Mobile Intel[®] Pentium[®] II Processor Specification Update

Release Date: April 2006

Order Number: 243887-052

The Mobile Pentium[®] II processor may contain design defects or errors known as errata which may cause the product to deviate from published specifications. Current characterized errata are documented in this Specification Update.

Figure 2. Workaround Flowchart: SMBALERT#-Driven System

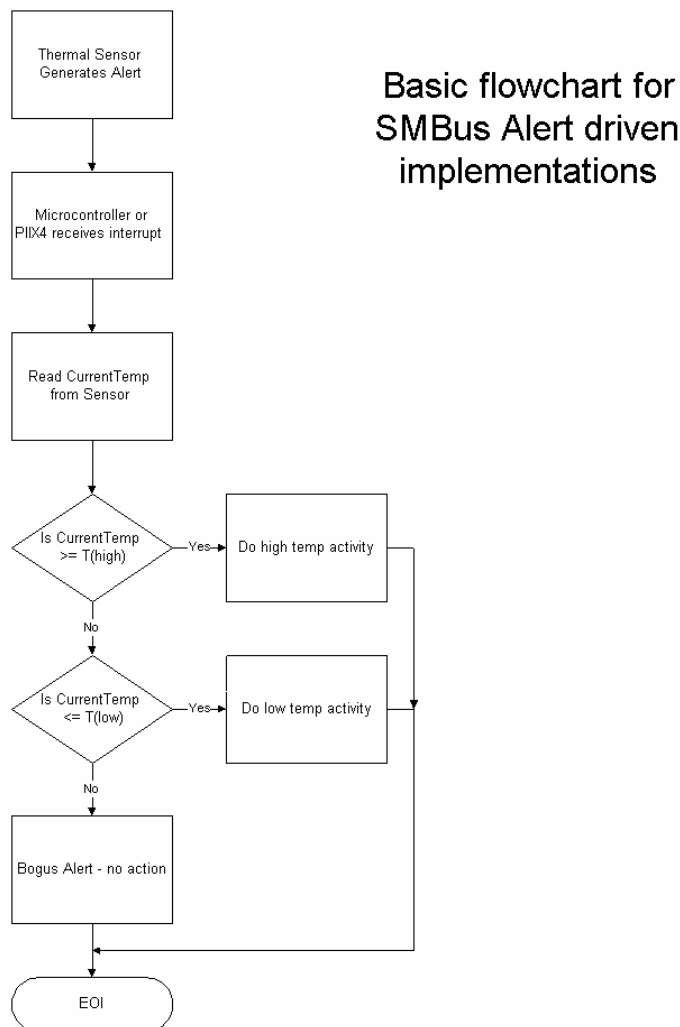
Problem: The Mobile Pentium II processor and the Pentium II Processor Mobile Module have a thermal sensor that monitors the processor core's temperature. Please note that desktop systems could have a similar thermal device. The thermal sensor asserts SMBALERT# if the processor temperature exceeds the temperature limits set in the Alarm Threshold Registers (T_{HIGH} , T_{LOW}). It also sets the corresponding Status Register bits to identify the cause of the interrupt. Figure 1 gives one example of the how the SMBALERT# signal could be used in a system.

Under the conditions described below, the thermal sensor incorrectly generates the SMBALERT# interrupt. All of the following conditions must be met to trigger a false interrupt:

1. Before servicing an interrupt from the thermal sensor, read and compare the processor thermal reading with the threshold limits (T_{HIGH} or T_{LOW}). Figures 2 and 3 provide basic flowcharts for the implementation of this workaround in an interrupt driven system.
2. If the firmware implemented polls the Status Register only, then before taking any action, re-read the temperature register and do a comparison with the alarm threshold limits (T_{HIGH} or T_{LOW}) to determine if the value is actually still within the temperature window.

3. Use a temperature polling scheme to monitor the processor temperature.

Figure 1. TAP Gageable Thread Clarification

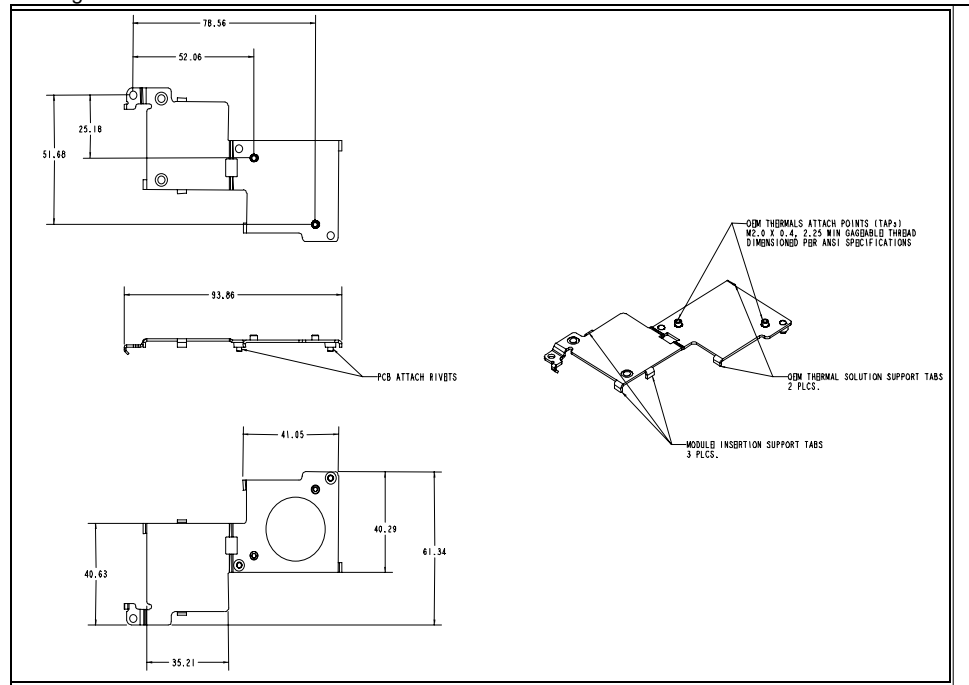
In the *Intel® Pentium® II Processor Mobile Module : Mobile Module Connector 1 (MMC-1)* and the *Intel® Pentium® II Processor Mobile Module : Mobile Module Connector 2 (MMC-2)* datasheets (Order Numbers 243667 and 243668, respectively), the thermal attach point (TAP) gageable thread specification was not clearly identified in Figure 14, of Section 5.2. The following is the TAP clarification:

OEM Thermal Attach Points (TAPs) M2.0 x 0.4, 2.25 min gageable thread dimensioned per ANSI specification.

See Figure 1 below for more information.
